CLIENT
GREENFIELDS
DEVELOPMENT COMPANY

PROJECT
ORAN PARK
RESIDENTIAL 4
PROJECT
NO 09

LOCATIO
CORNER OF SOUTH
CIRCUIT & DAIRY
STREET, ORAN PARK

SHEET TITLE
SHADOW DIAGRAMS

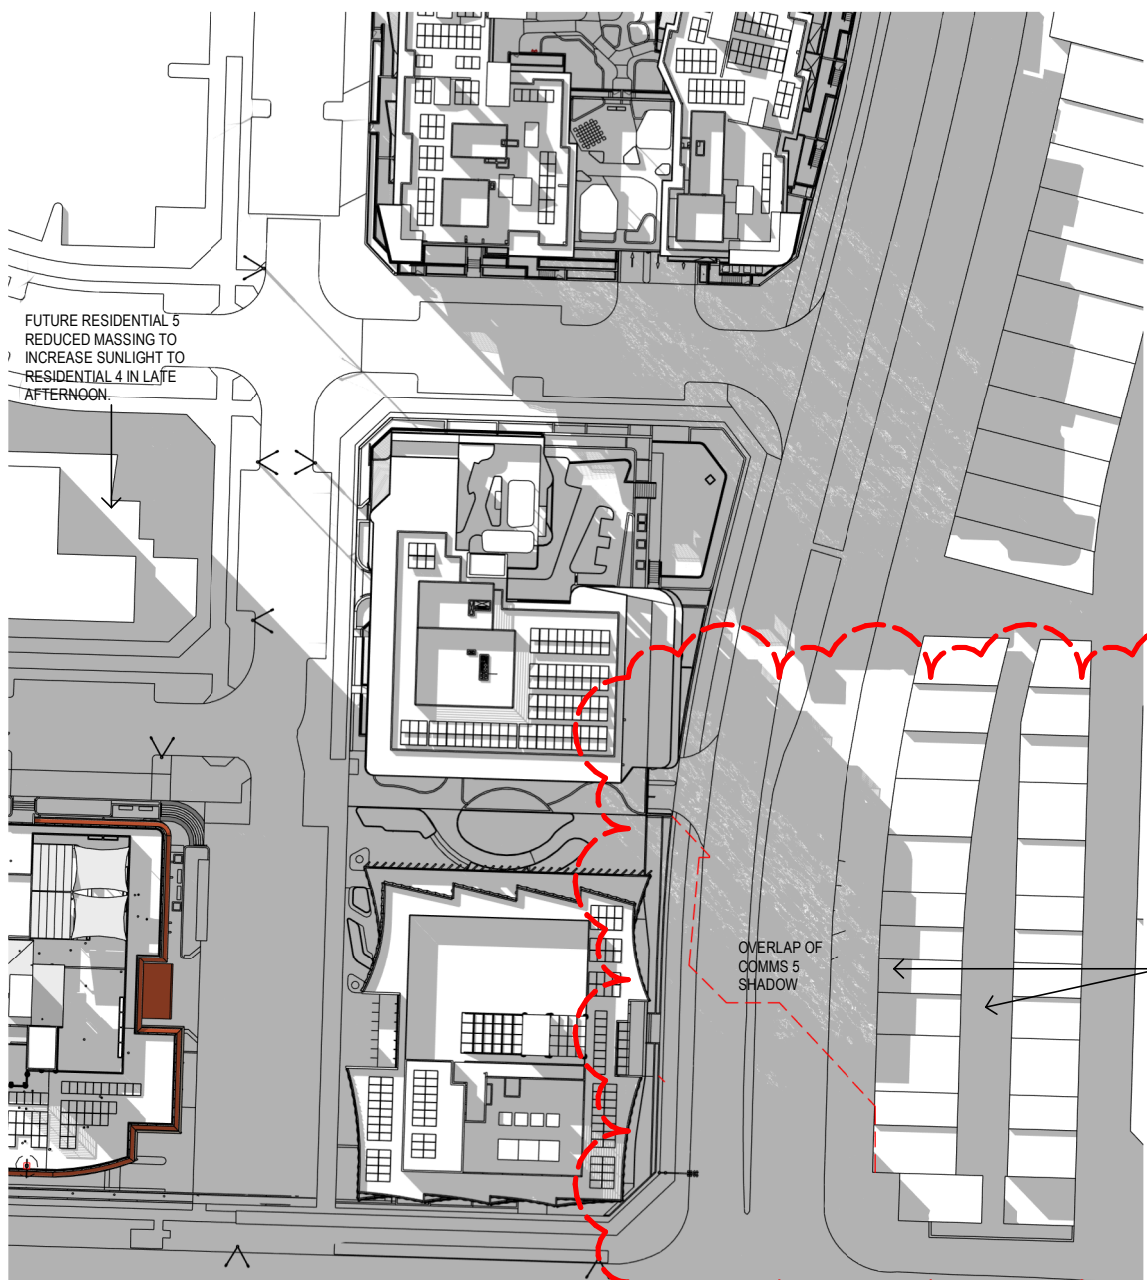
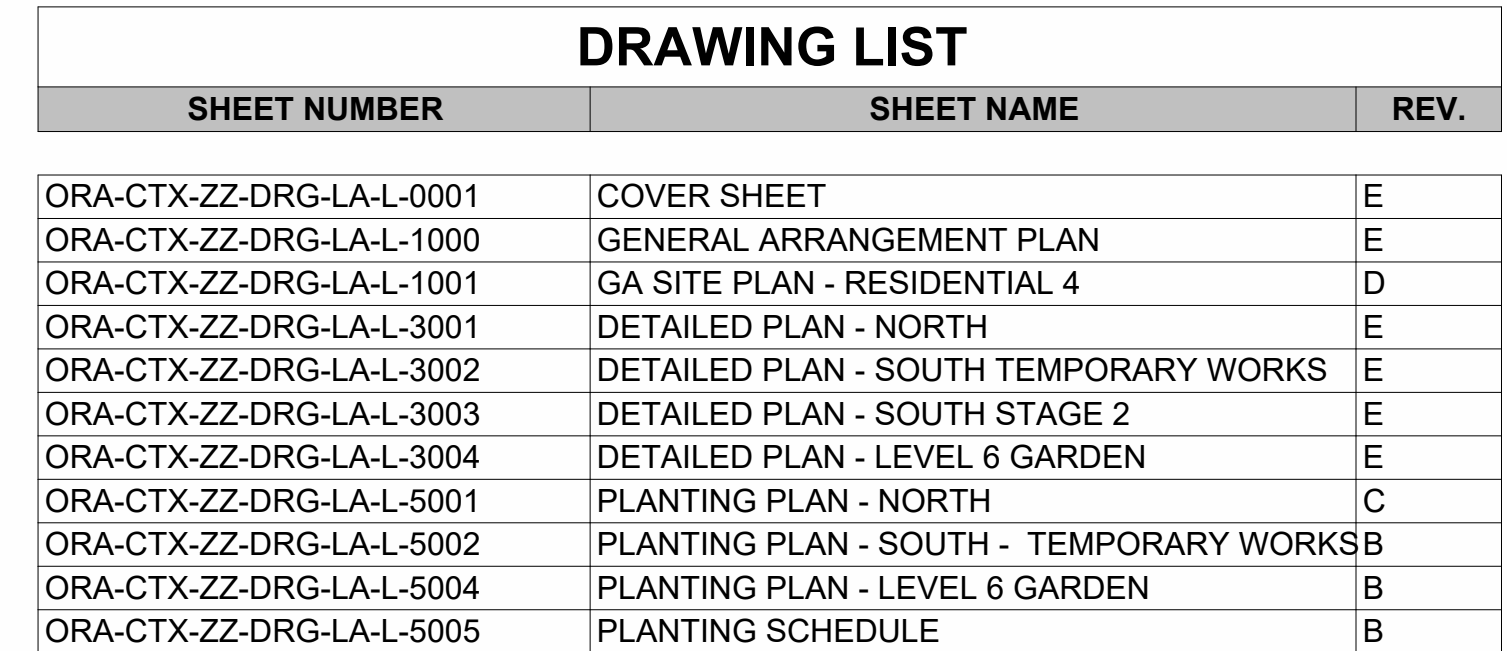
7 SHADOWS TO NEIGHBOURING HOUSES CLARIFIED

OVERLAP OF CORNER'S SHADOW
SHADOW OVERLAPS ON TO SMALL PORTION OF HOUSE'S FRONTAGE ROOF
NO SHADOW IMPACT INTO LIVING SPACES AT REAR OF PROPERTY
